RECEIVED
HOWARD COUNTY
HEALTH DEPT.
ELLCOTT CITY, MD

PENN SHOP RD

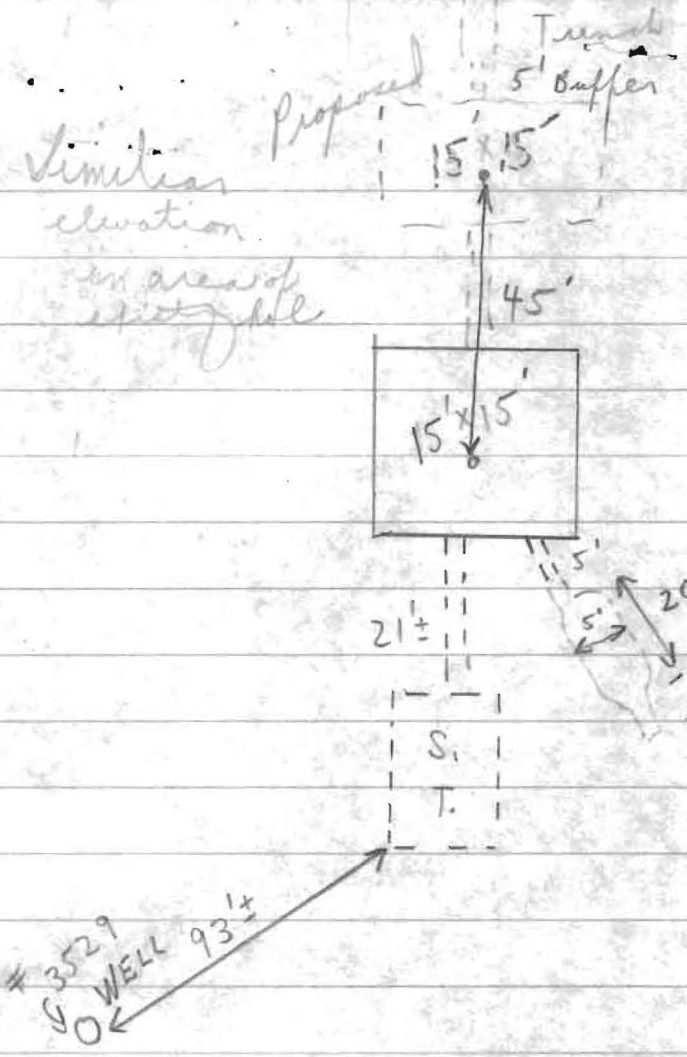
well location lower elevation than
sewage disposal area.

Mr. Browning would like to do away with covered trench and put another dry well and trench off last dry well. Hold & discuss with Mr. C.B. & F.F.

This granting does not constitute approval
of the well site. Only approval is for
the grant. DWM

{ A.M. 5/2/80 Discussed with Mr. Moran
ok for 2 dry wells + trench off
back dry well
C.B. & D.W.M. }
✓ Stop in P.M. + note on card.
C.B.
